Project:	Former Merseyside Dogs Home, Halewood	Scheme No:	14506
Subject:	Technical Note - Repsonse to EA Comments	Revision:	02
Client:	BBE Developments Ltd	Date:	29/07/2024
Author:	Aled Williams BSc (Hons) MCIWEM C.WEM

This Technical Note has been prepared in response to an Environment Agency (EA) objection to a proposed residential development at the Former Merseyside Dogs Home, Greensbridge Lane, Halewood, L35 1QH (planning reference 23/02710/FUL). This Technical Note should be read in conjunction with the Waterco Flood Risk Assessment (reference 14506-FRA-04) and the Waterco Hydraulic Modelling Report (reference 14506-25072-HMR-3).

Figure 1 – In Channel Node Locations

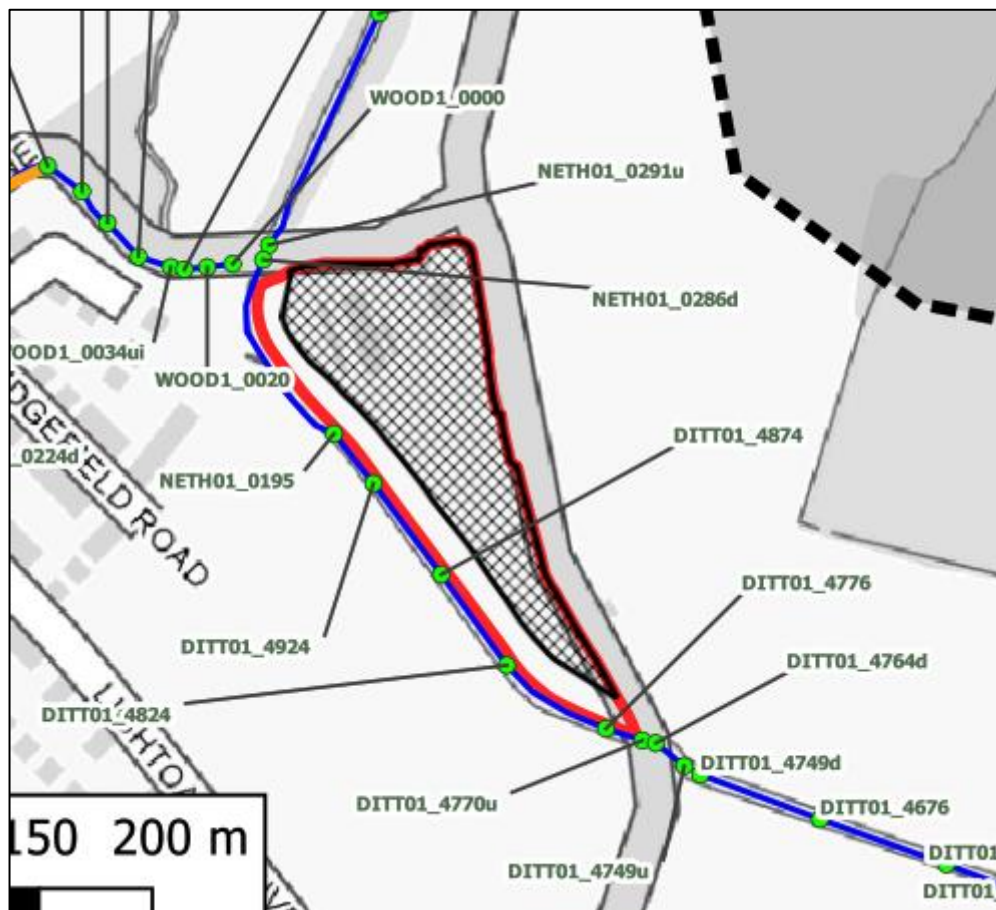
Development in Flood Zone 3, including raising ground levels, is likely to displace flood water from the site and transfer this risk elsewhere. The submitted FRA (ref: Waterco/14506-FRA-04/June 2024) states 'impact on flood risk

elsewhere as a result of the development is negligible'. However, while there are pre- & post-development modelled outputs provided that do not show significant increases in flood levels in the proximity of the site, we would highlight that without suitable flood storage volume compensation being provided any displaced floodwater from the site has to be diverted elsewhere. It is therefore this volumetric loss that we are seeking the FRA to address. Additionally, where hydraulic modelling outputs alone do not detect a significant increase in flood risk

elsewhere from small-scale development sites, we would highlight the issue of a cumulative impact of flood storage not being provided and having a potential impact of exacerbating flood risk elsewhere without detection. Any loss of flood storage from Flood Zone 3, must be compensated for like-for-like so as to not increase flood risk elsewhere and contribute to a negative cumulative effect, incorporating fully the impact of climate change over the lifetime of the development.

Detailed hydraulic modelling has been undertaken by Waterco to determine the impact of the development (ground raising) on the flood flow route on site and the resulting impact on flood risk elsewhere. As detailed in the FRA and Hydraulic Modelling Report, the proposed development does not increase flood risk elsewhere and as such flood compensation storage is not considered to be necessary.

Tables 1 and 2, extracted from the Waterco Hydraulic Modelling Report show that there are no changes in the in-channel water levels in Netherley Brook as a result of the development. The corresponding in-channel node locations are shown in Figure 1.
